Docket Number:	08-AFC-09C
Project Title:	Palmdale Hybrid Power Project - Compliance
TN #:	201500
Document Title:	Letter re Review of Requested Inter-District Transfer of ERCs from Mojave Desert Air
Description:	N/A
Filer:	Darlene Burgess
Organization:	Pless Environmental, Inc.
Submitter Role:	Public
Submission Date:	12/31/2013 11:53:43 AM
Docketed Date:	12/31/2013

Re: Review of Requested Inter-District Transfer of Emission Reduction Credits from Mojave Desert Air Quality Management District and San Joaquin Valley Air Pollution Control District, Respectively, to Antelope Valley Air Quality Management District for Use as Offsets for Palmdale Hybrid Power Project

Figure 3: CARB nonattainment area classification for 1-hour state ambient air quality standard for ozone
(from: CARB, 2012 State Area Designations, 1-hour Area Classification Map, approved December 28, 2012, effective April 1, 2013; http://www.arb.ca.gov/desig/adm/s_classif.pdf)

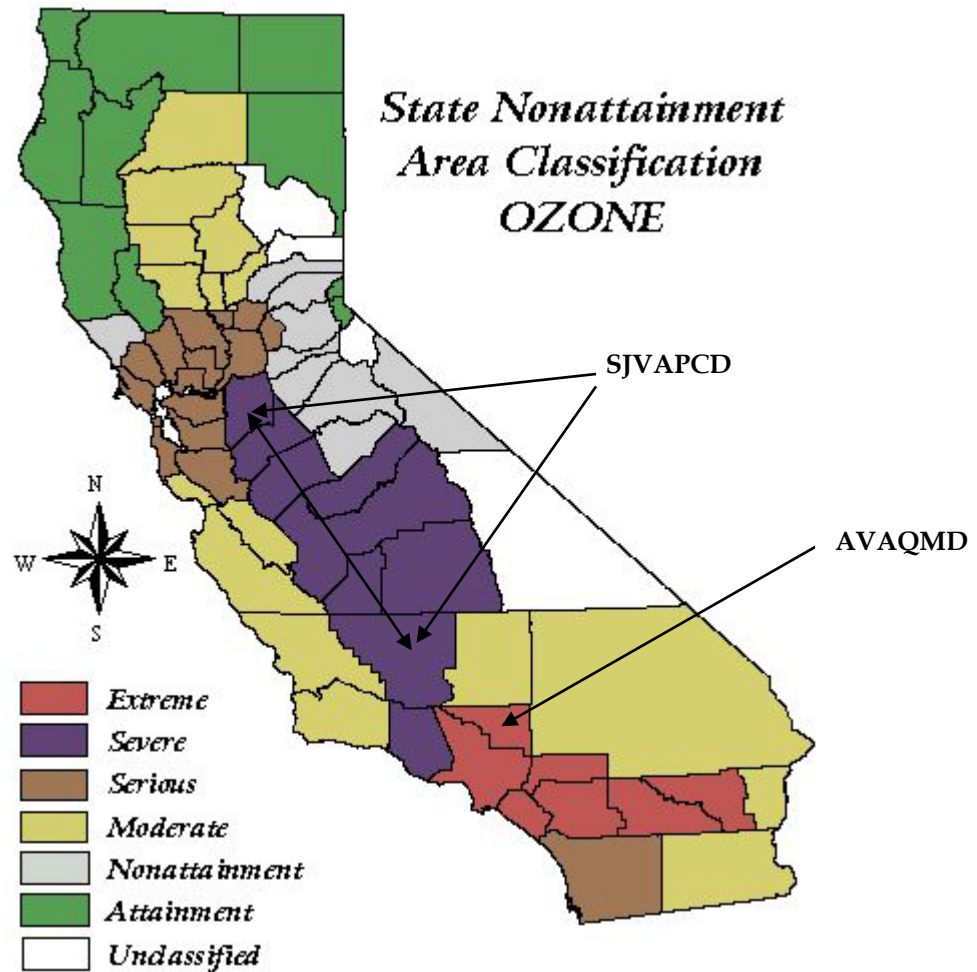
As discussed before, the SJVAPCD has jurisdiction over the San Joaquin Valley Air Basin and the AVAQMD has jurisdiction over the western portion of the Mojave Desert Air Basin. The CARB designated both the San Joaquin Valley Air Basin and the Mojave Desert Air Basin as “nonattainment” with the state ambient air quality standard for ozone.⁵⁶ Further, as shown in Figure 3 below, CARB classified all counties under the SJVAPCD’s jurisdiction as “severe” nonattainment with the 1-hour state ambient air quality standard for ozone per Health & Safety Code Section 40921.5(a) for ozone concentrations between 0.16 and 0.20 parts per million. CARB classified the AVAQMD as “extreme” nonattainment for the 1-hour ozone state ambient air quality standard for ozone per Health & Safety Code Section 40921.5(a) for ozone concentrations in excess of 0.20 parts per million.⁵⁷

Thus, the upwind district, *i.e.*, the SJVAPCD, is classified by CARB as having a comparatively better nonattainment status (severe) than the downwind district, *i.e.*, the AVAQMD (extreme). Therefore, based on my review of all the evidence the proposed inter-district/inter-basin transfer of VOC ERCs from the SJVAPCD to the AVAQMD does not comply with Health & Safety Code Section 40709.6(a)(1), which requires that the upwind district be classified as having a worse nonattainment status than the downwind district.

Figure 4: Monitoring values for 8-hour NAAQS in MDAB

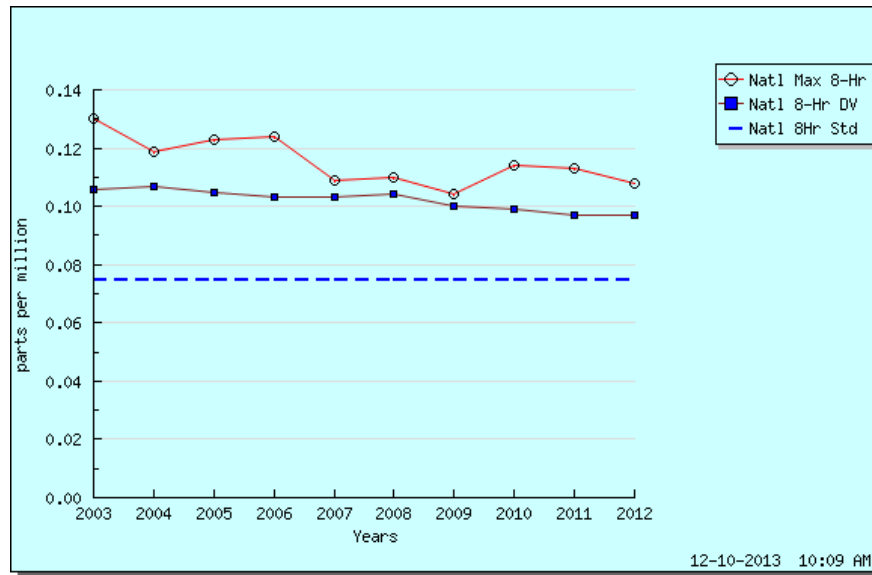
While some improvement in ozone concentration could be observed over the past decade, as shown in Figure 4 below, the Mojave Desert Air Basin is a long way from achieving attainment with the federal 8-hour ozone standard.

Figure 5: Monitoring values for 8-hour CAAQS in MDAB

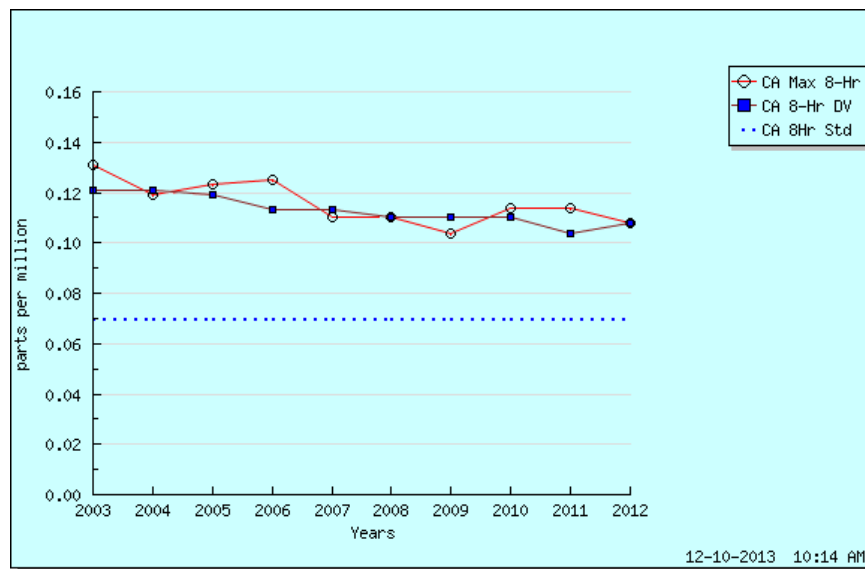
Similar observations can be made about the air basin's progress towards attainment with the 8-hour state ambient air quality standard for ozone for ozone from 2003 through 2012, as shown in Figure 5 below.

Figure 6: Monitoring value for 1-hour CAAQS in MDAB

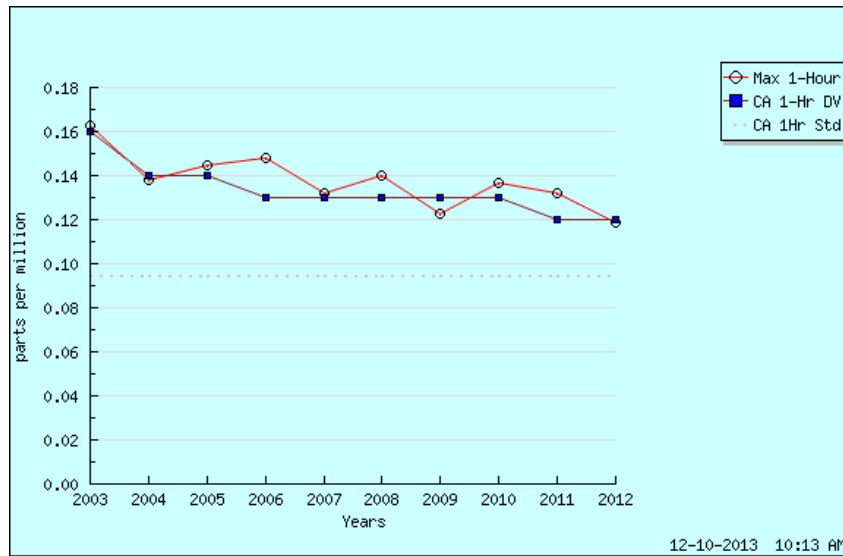
Ozone concentrations determined for the Mojave Desert Air Basin for the 1-hour state ambient air quality standard for ozone from 2003 through 2012, shown in Figure 6

below, again show some improvement but are still far above the state ambient air quality standard for ozone.

Figure 7: Days over the 1-hour and 8-hour CAAQS and 1-hour (revoked) and 8-hour NAAQS in the MDAB

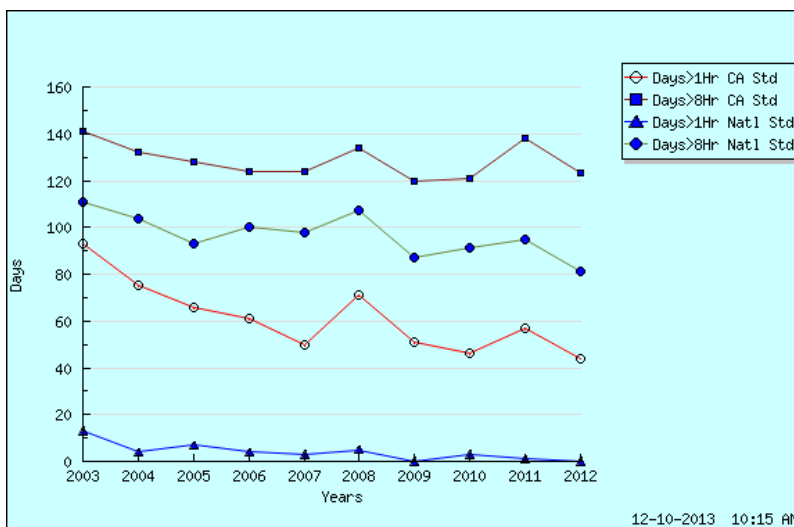
Finally, Figure 7 below, illustrates the number of days per year when ozone concentrations exceeded the state and national ambient air quality standards, *i.e.*, when residents of the Mojave Desert Air Basin breathe unhealthy air due to ozone pollution.
